MEMORANDUM

REFERENCE No. 1658927-Commitment 4

ECCC AND AGNICO EAGLE MEETING: WHALE TAIL PIT AIR QUALITY MONITORING STATIONS

Whale Tail Pit – Air Quality Monitoring Stations (presented during May 18, 2017 WebEx)

Proposed Monitoring Location(s)

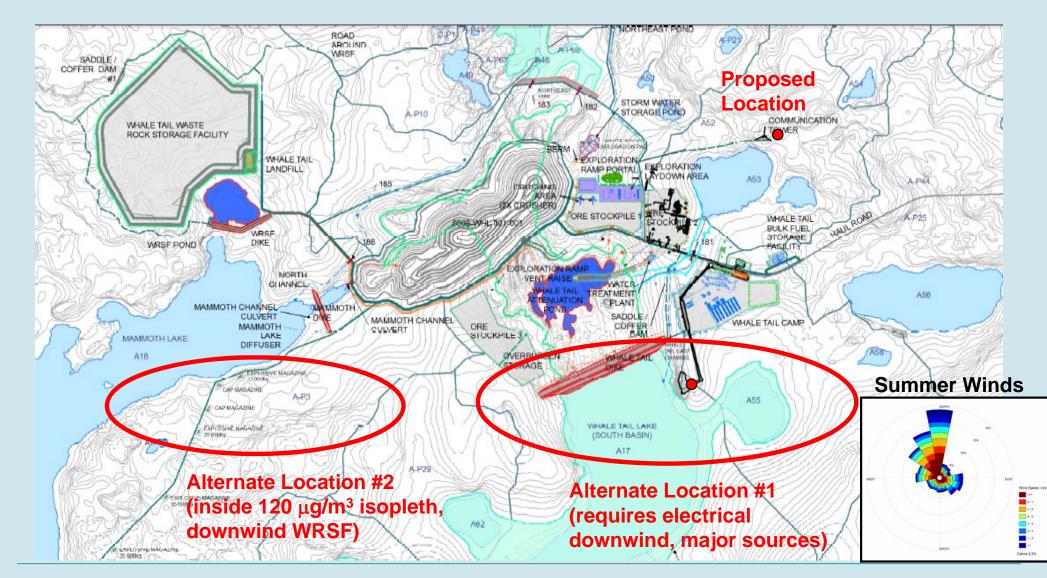
- Roundtable discussion of the proposed monitoring station and Alternative Locations
 - Proposed location (Communications Tower)
 - Tower & electrical utilities already in place.

- Not a lot of traffic nearby.
 - Sits on a predicted gradient in PM concentrations; will be able to measure background concentrations.
 - Alternate Location #1 (esker south of old runway)

- Best downwind location with respect to prevailing summer winds
 - Close to camp and generators (<500 m)

- Approximately 1 to 2 km from the Pit
- Existing gravel road, but requires running electrical utility corridor approximately 400 to 500 m.
- Alternative Location #2 (Emulsion Plant)

- Least desirable location with respect to PM_{2.5} emissions from Whale Tail sources
 - Adjacent to Emulsion road so will require running at least 200 m of electrical utility corridor

- Downwind of Waste Rock Piles (a new topographical feature)
 - Lower elevation
- Winds are predominately from North and Northwest; summer time is the focus for monitoring winds during this time are from the North

- ECCC suggested incorporating a supplemental station with low power to monitoring PM_{2.5} downwind of the pit
- Based on discussions and further analysis, Agnico Eagle indicated that the location presented in the Air Quality Monitoring Plan will remain unchanged as of now and the Plan will be updated in future iterations based on evaluations and investigations by Agnico, and regulatory review of annual reporting (see commitments)

- Evaluate adding a supplemental low powered monitoring station downwind of site; FRM/FEM distinction for the analyzer is not necessary for the supplementary site
- 2) Prior to operations, Agnico Eagle will investigate the costs of running electricity to Alternative Location #1
- 3) Assess relocating the proposed monitoring station once site infrastructure is in place
